Alliance for Automotive Innovation

Comments

**Revised 2023 and Later Model Year Light-Duty Vehicle Greenhouse Gas Emissions Standards;
Proposed Rule**

**Submitted to Docket ID Nos.
EPA-HQ-OAR-2021-0208
NHTSA-2021-0053**

Figure 1: Combined passenger car and light truck annual GHG performance and comparison to annual targets, MYs 2012-2020. Source: Baseline Study (*supra* note 34).

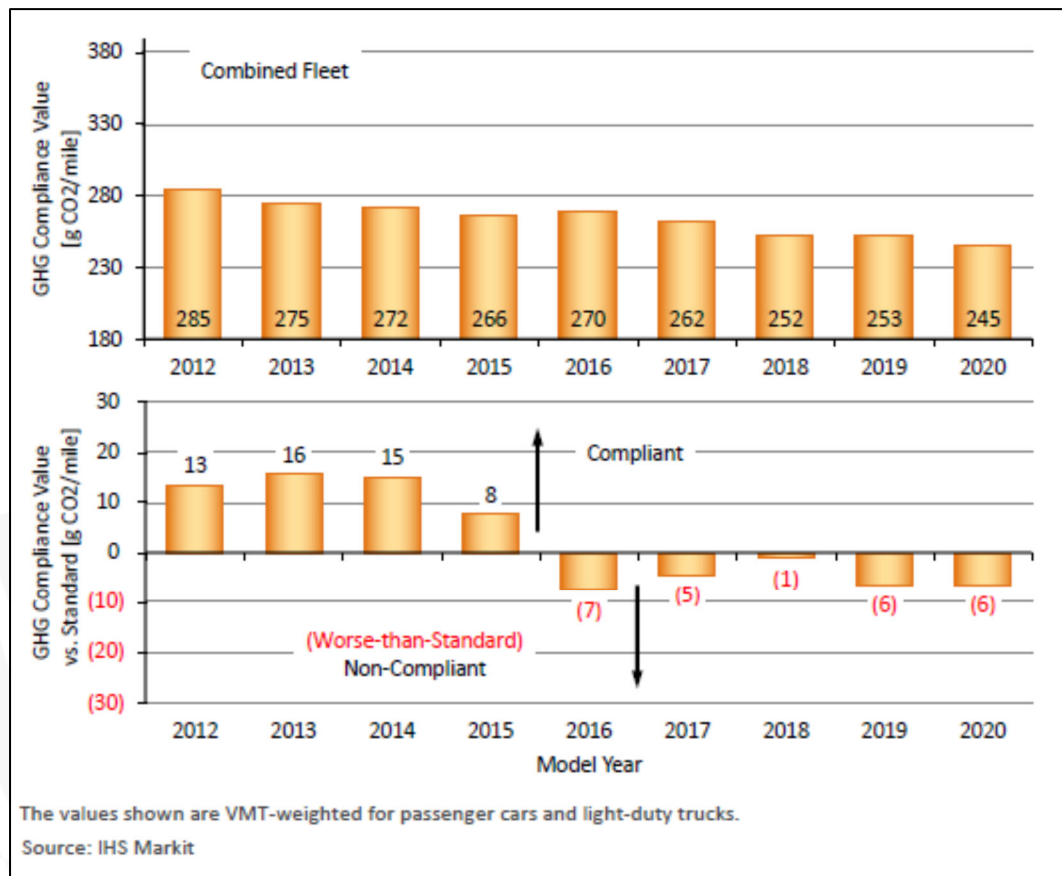
According to the most recent IHS Markit “Baseline Study,”³⁴ fleet average performance improved in MY 2020 but continued to fall short of annual requirements (Figure 1). Comparing MY 2020 values from the Baseline Study to those estimated by EPA for the NPRM, manufacturers would

have to improve U.S. fleet average performance, net of credits, by 18% overall between MY 2020 and MY 2023 to meet the proposed MY 2023 targets.³⁵

These types of performance gains are usually only obtained through combined vehicle and powertrain redesigns or significant market shifts in powertrain choices. Given that four years is a short time for vehicle redesigns and extremely short for powertrain redesigns, it is unlikely that the entire fleet would be improved to this level. Thus, the burden would fall to a combination of changes to the smaller volume of vehicles actually redesigned and potential fleet mix changes where those actions fall short.

Figure 2: Sales weighted percent of fleet achieving existing (MY 2020-2022) and proposed (MY 2023-2026) GHG targets by powertrain type, assuming MY 2020 credit levels. Source: IHS Markit Baseline Study.

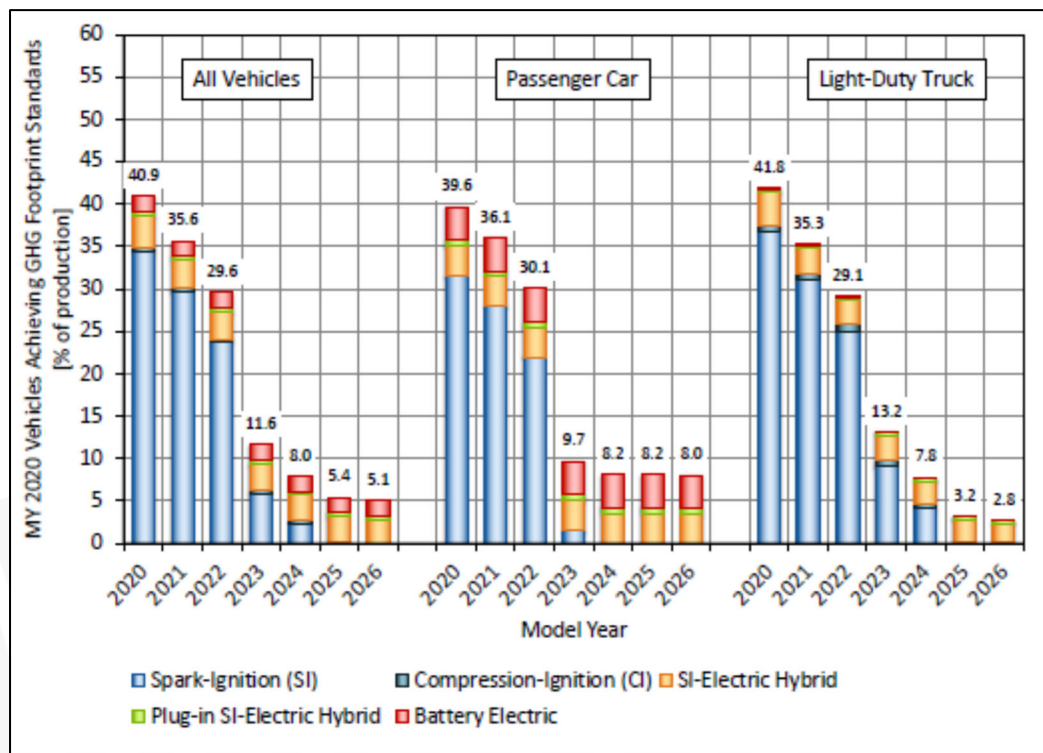
IHS Markit also assessed MY 2020 fleet performance against future targets including MY 2023 (Figure 2). Only 11.6 percent of vehicle production in MY 2020 meets MY 2023 targets. Assuming a normal distribution of vehicles above and below target, this would need to be improved to roughly 50 percent between MYs 2020 and 2023 for the fleet on average to meet its annual target (or higher to generate credit). Note that, despite the presence of some EVs in MY 2020, with only 41 percent of

production meeting or exceeding annual targets (Figure 2), the fleet as a whole is still a net deficit generator (Figure 1).

As shown in Figure 2, MY 2020 vehicles (many of which already include ICE technologies modeled by EPA) were also assessed against the MY 2026 proposed targets. In the MY 2020 fleet, only EVs are capable of meeting the proposed MY 2026 targets. The same holds true for the proposed MY 2025 targets.

Figure 3: Relative efficiency gain with higher octane fuel rating. Raising octane enables engine compression ratio increases, resulting in improved engine efficiency. Source: Leone *et al.* (*supra* note 120).

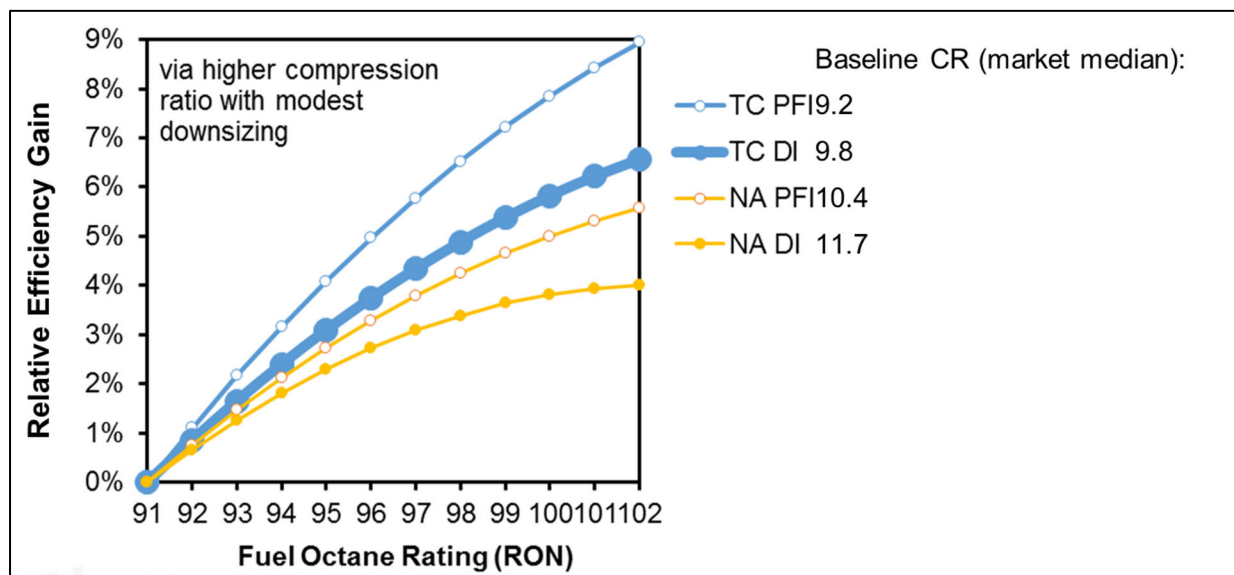
The relative efficiency gain enabled by higher octane rated gasoline is well documented. A literature review published by Leone et al. shows that increasing fuel octane rating from 91 RON to 95 RON facilitates an increase in efficiency by three to five percent.¹¹⁸ Figure 3 shows the correlation of efficiency gain enabled by higher octane rated fuels with higher compression ratio engines.

Auto Innovators and its predecessor associations have long advocated that EPA should require a transition to a higher minimum-octane gasoline (minimum 95–98 RON). There are several ways to produce higher octane-grade gasoline. Increasing the ethanol content of gasoline is one approach. Hydrocarbon composition changes are another. Reducing the proportion of low octane naphtha or increasing the proportion of higher-octane streams such as alkylate or reformat will result in higher octane fuels. Ethanol blends higher than E10, with misfuelling mitigation measures in place, have been suggested by some to provide better value to consumers to achieve higher octane numbers and reduce carbon emissions. Auto Innovators does not promote any sole or particular pathway.

Figure 4: Comparison of EIA and Global Insight projected gasoline prices.

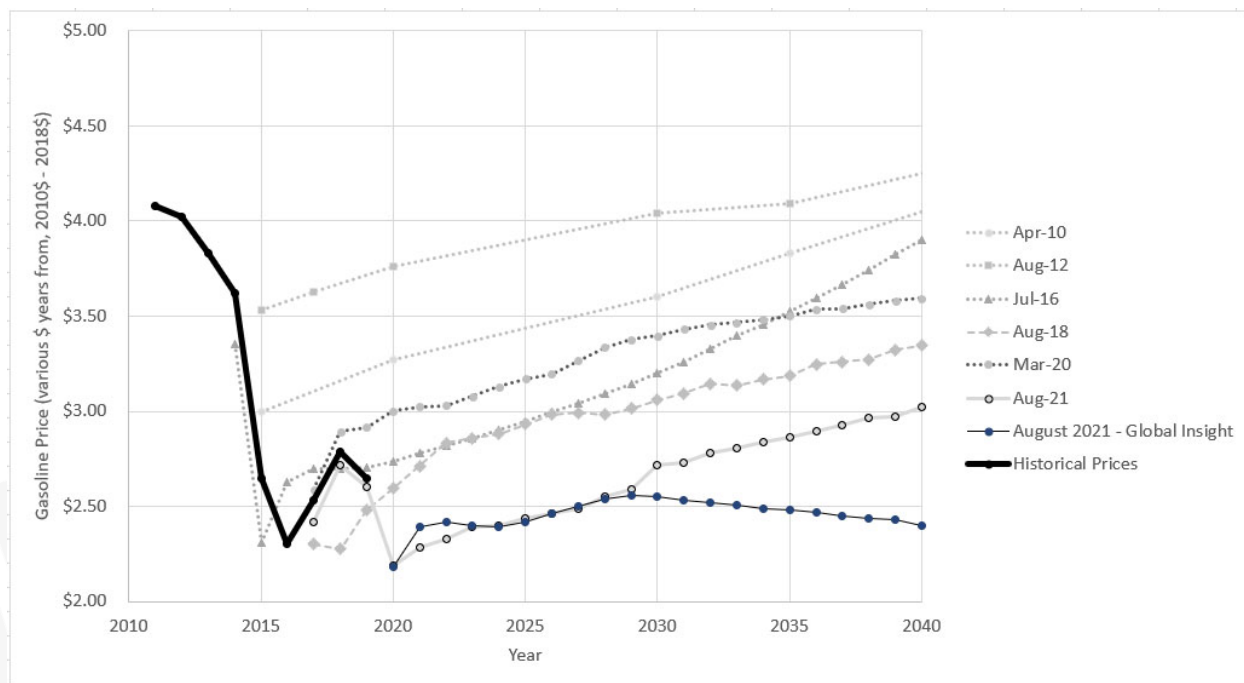
Both the EPA and DOT analysis use—and have used—forecasts from the U.S. Energy Information Administration for fuel prices in their central analyses. Over the last decade (as shown in Figure 4 below), these fuel price forecasts have significantly overestimated the national average price of gasoline, which has in turn overstated the projected benefits of increases in stringency and improving fuel economy for consumers in the near term. Over the last decade, the long-term price outlook for gasoline has steadily declined as well, both in the EIA forecasts, and in private sector forecasts.

Interestingly, DOT included a sensitivity case for gasoline prices, as forecast by Global Insight. This is a credible source, alongside the EIA forecast. Both forecasts have a similar trajectory and values from 2022-2029, but they depart significantly in 2030 and beyond. Gasoline prices are volatile, and difficult to predict. Both EPA and DOT show U.S. consumption of gasoline decreasing significantly in the long term, as fuel efficiency of light duty vehicles improves in response to stringent alternatives, and as the fleet transitions towards electrification. Auto Innovators encourages policymakers to review the assumptions underlying the EIA gasoline price forecast, including assumed domestic consumption of fuel, and the extent to which plug-in vehicles are assumed to be adopted, and review the extent to which those assumptions are consistent with the policy objectives for light-duty vehicle electrification as stated in recent executive orders. If the EIA Central Case gasoline forecast assumes fewer than 50% plug-in vehicles by 2030, Auto Innovators encourages use of the Global Insight gasoline price forecast in the Central Case for both EPA and DOT analysis.

To the extent that gasoline prices may remain low in the long-term (perhaps reflecting depressed demand for gasoline, as shown in both of the Agencies' analysis), consumers may require additional incentives to transition towards plug-in vehicles.
